Examination Outline Cross-reference:	Level	RO	SRO
	Tier #	2	
	Group #	1	
	K/A #	205000 K1.04	
	Importance Rating	2.7

Proposed Question: Common 1

Proposed Question: Common 9

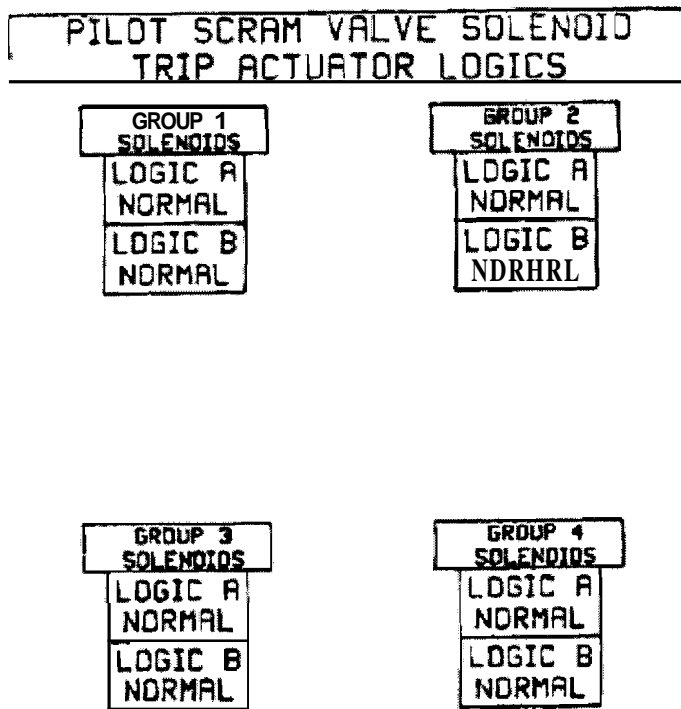
Is there a way to ask this using an incomplete sequencing scenario – leave as is

GENERATOR REACTIVE CAPABILITY CURVE

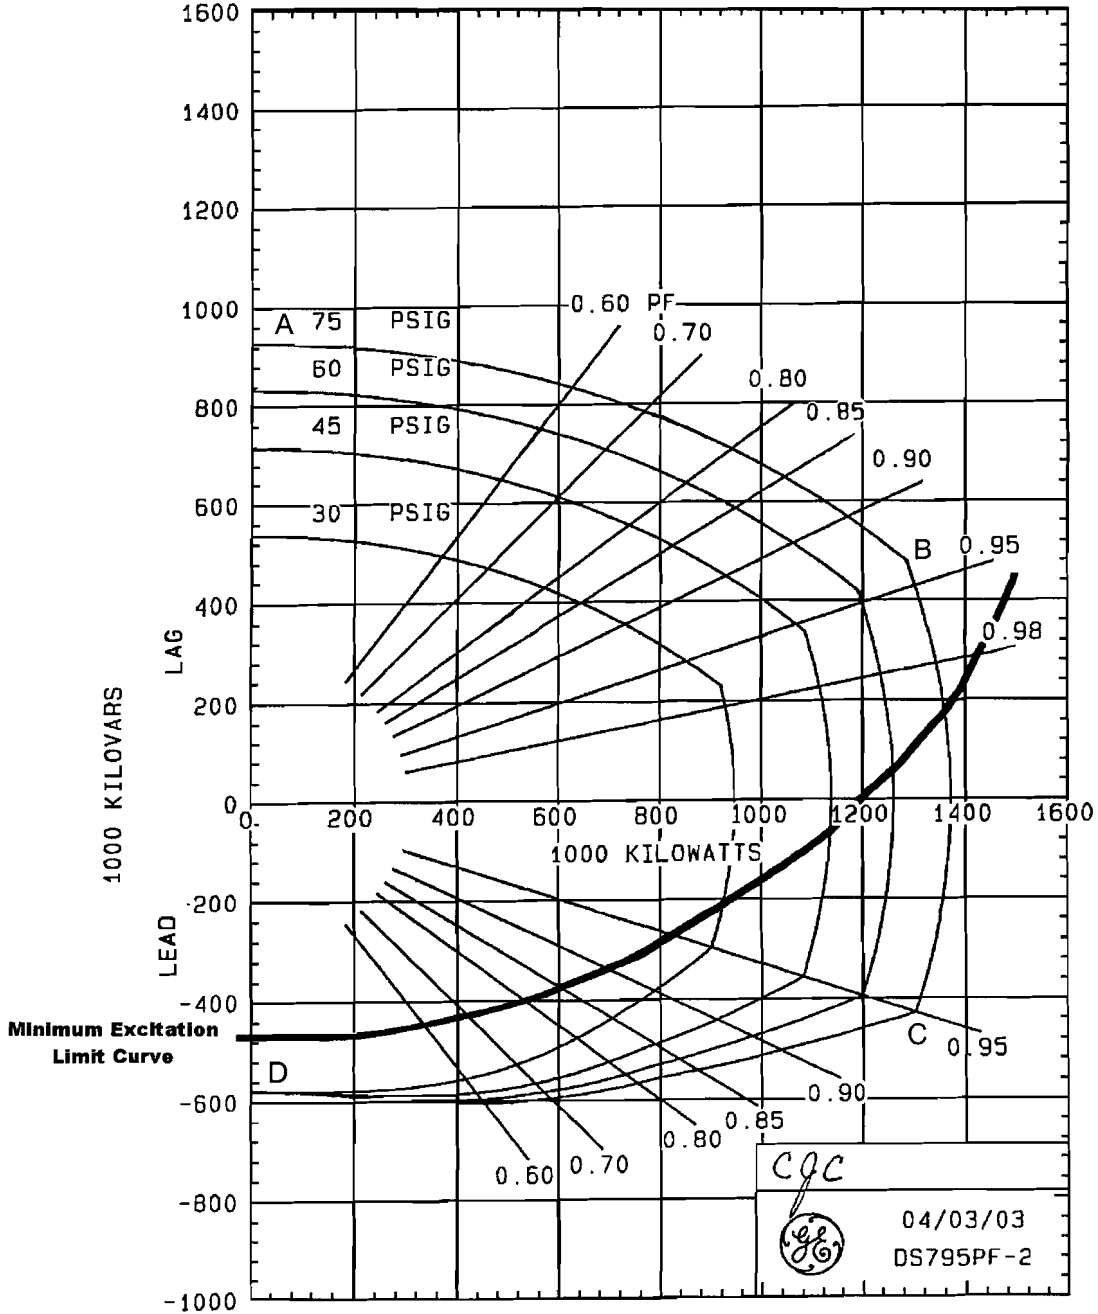
Explanation (Optional): Per the curve (see markup), the region for Armature Heating would be exceeded (BC region)
